FIELD SERVICE BULLETIN

FSB Number: BJCCFSB2004--118
Author: Fang Hong
Date: May 24. 2004
Total No. Of Pages: 3
Subject: **V878 (TCH) LCM FPC and Connector aren't match Issue**
Model Affected: **V878 (TCH) GSM/DCS/PCS**
Level of Repair: 3

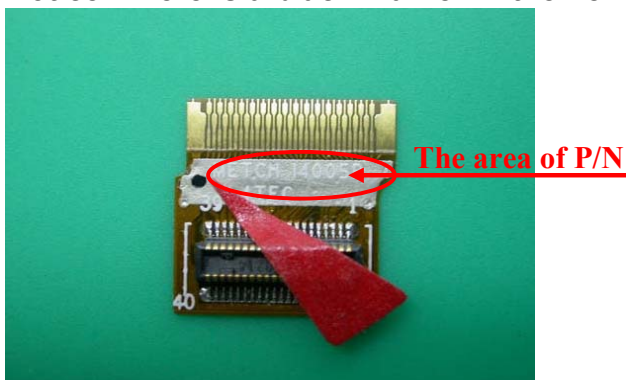
An issue was identified during analysis of returned V878 units. Some handsets have been returned with the customer complaint of 'No Display'. Several symptoms are related with LCM FPC:

1. White Display when power on.
2. White Display when installing the battery.
3. No display and No backlight when power on.

PIC 1

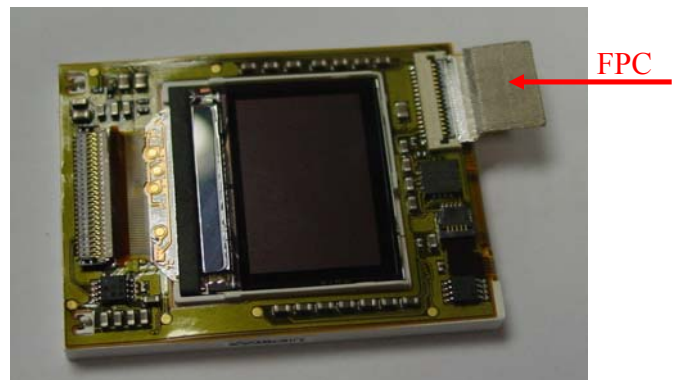
This issue is due to LCD module FPC can't match with connector. Improvement FPC has been implemented from 19 April.

- The new part number is METCH14005B, and there is a black marker in the FPC as the picture shows.
- The old part number is METCH14002B or METCH14005B without black marker.

Notice: There is a black marker in the new FPC

If the symptom disappears, replace a new FPC (P/N: METCH14005B).
